BASEMENT IMPACT ASSESSMENT ADDENDUM_2
20A FERNCROFT AVENUE
LONDON
NW3 7PH

CLIENT: Mr Elliot Graff
20A Ferncroft Avenue
London, NW3 7PH

JOB NO: P19-461

DATE: 9th April 2020 – Rev 0

Image: extract of sketch showing loading applied to retaining walls revised March 2020.

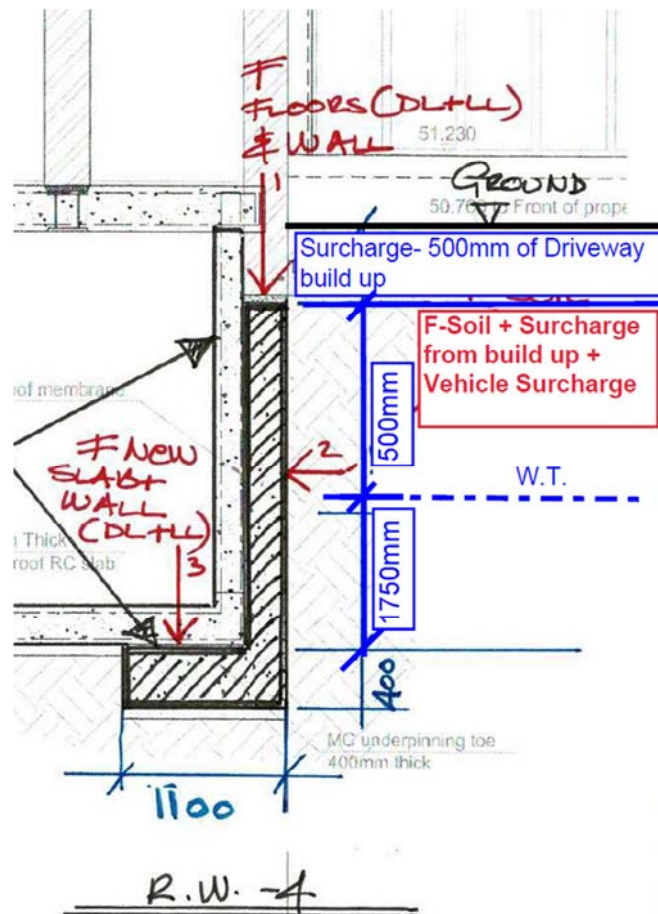
Query No	Subject	Query	Status	Date closed out
1	Stability	Clarification required with respect to excavation depth and nature of basement retaining walls.	Structural calculations and sketches, and GMA, refer to RC walls. Assumed reference to mass concrete in original BIA is error. To be confirmed. Depth of basement described as 3.00 to 3.50m in BIA addendum and GMA. Structural calculations give retained wall heights of max 2.375m but allow for surcharge from retained soil above.	24/03/20
2	Stability	Retaining wall calculations to be revised to reflect recommendations in hydrogeological assessment.	Open - BIA addendum states walls to be designed for water at 1m bgl but structural calculations unchanged with exception of shear resistance.	
3	Stability	Building damage assessment to be reviewed to ensure consistent with anticipated ground movements.	Open - Clarification required as described below

REPLY TO QUERY No1

The 3.0m to 3.5m described as the depth of the basement in our report is referring to the vertical distance from the ground floor to the bottom of the base of the wall foundations.

The top level of the drive way is 50.780m; the top of the concrete wall for the basement underpinning the existing walls is below the ground level. Therefore the effective height of the concrete wall from the top of the wall base is 2375mm circa, and the loading from the soil above is considered as an additional surcharge.

As shown in the above sketch the all retaining the soil next to the garage is loaded with a surcharge equivalent to 500mm of retained soil.

Image: Diagram of retaining wall with 910mm of water and relative shear and bending moment diagrams

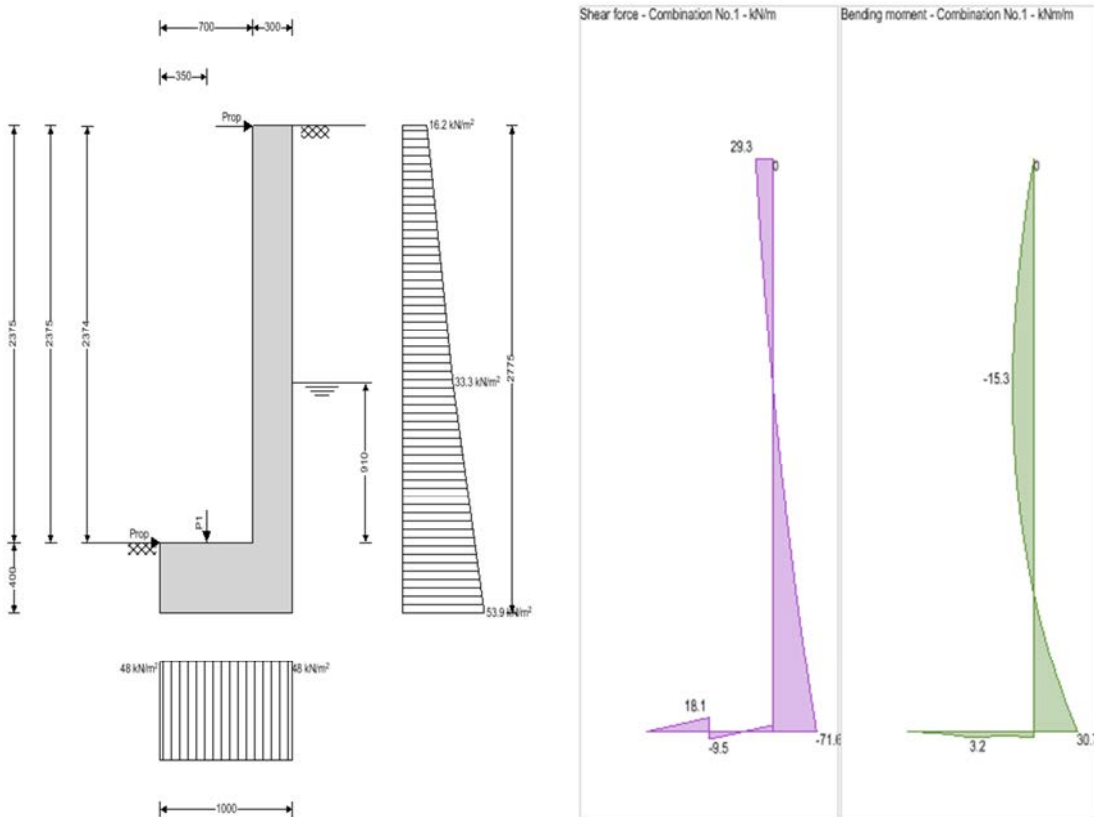
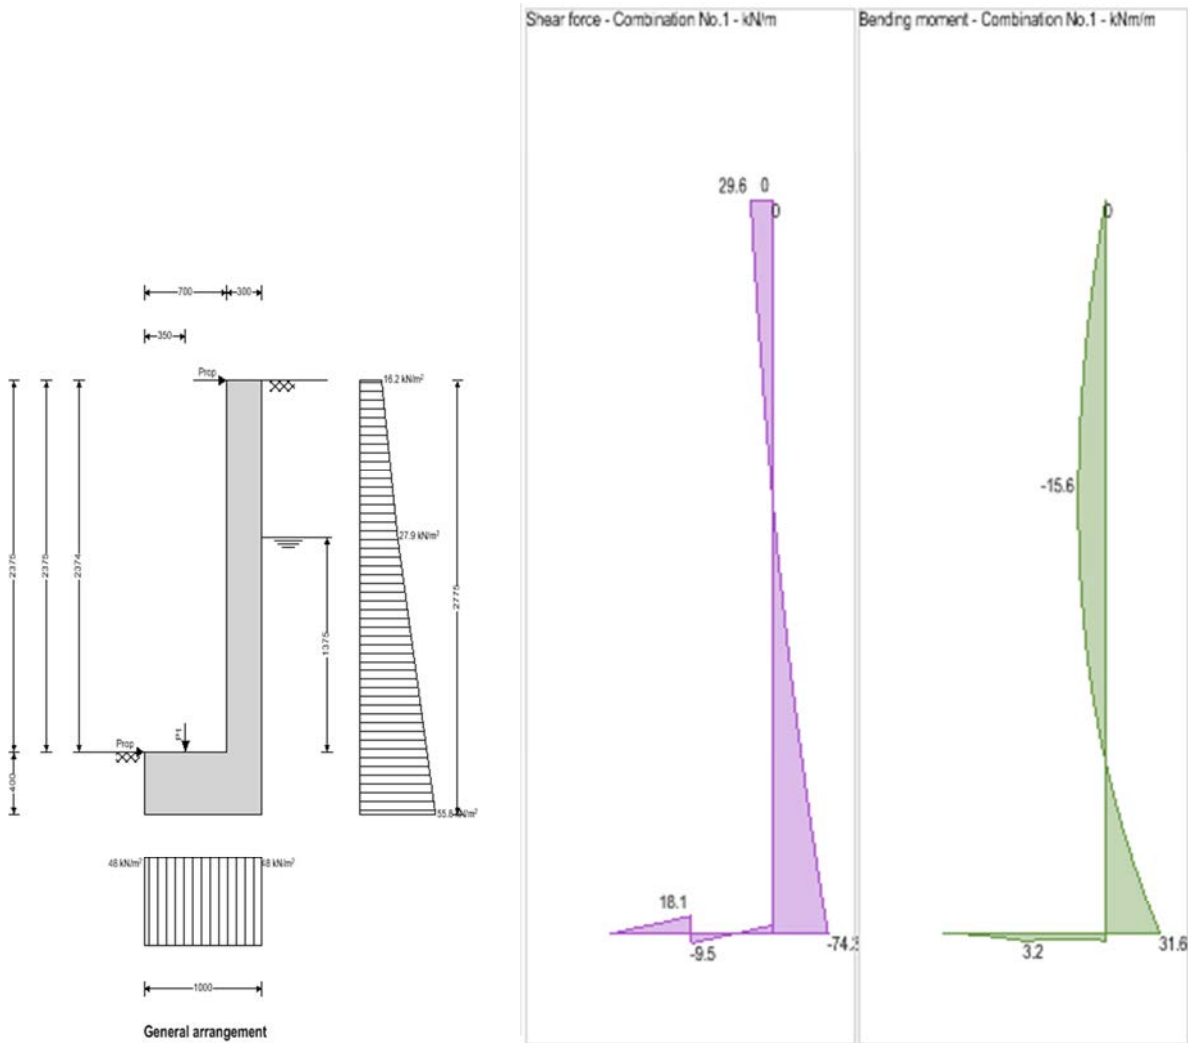
- 1. Clarification required with respect to excavation depth and nature of basement retaining walls,
- 2. Retaining wall calculations to be revised to reflect recommendations in Hydrogeological assessment,
- 3. Building Damage Assessment to be reviewed to ensure consistent with anticipated ground movement
- 4. Impact of infiltration tank to be considered

REPLY TO QUERY No2

For the purpose of this response I have taken retaining wall No 1 as an example:

In our original report we looked at a retained water level of 910mm, in the second revision we looked at a retained water level of 1375 which is 1m bgl. The difference in horizontal force applied is approximately 7kN applied relatively close to the base.

The wall in its permanent state will be propped both at the bottom and top by the concrete floors. With a retained level of 910mm the maximum moments obtained by the analysis performed were 15.3kNm on the lever arm and 30.7kNm at the stem. With a retained water level of 1375mm the maximum moments obtained 15.6kNm / 31.6kNm.

When designing the reinforcement for the wall the minimum rebar required for the depth of the wall is 368mm²/m. The required reinforcement for the wall retaining 910mm of water is 152mm² for the lever arm and 304mm²/m at the stem. The required reinforcement for the wall retaining 1375mm of water is 155mm²/m for the lever arm and 314mm² at the stem. Therefore for both cases the minimum required reinforcement will be 368mm²/m.

The utilisation ratios in our report are obtained using the provided and minimum required rebar therefore there will be no change in the flexural reinforcement utilisations of the two scenarios.

We have slightly changed our required shear reinforcement and modified the utilisations accordingly.

Overturning is not checked when propped both top and bottom.
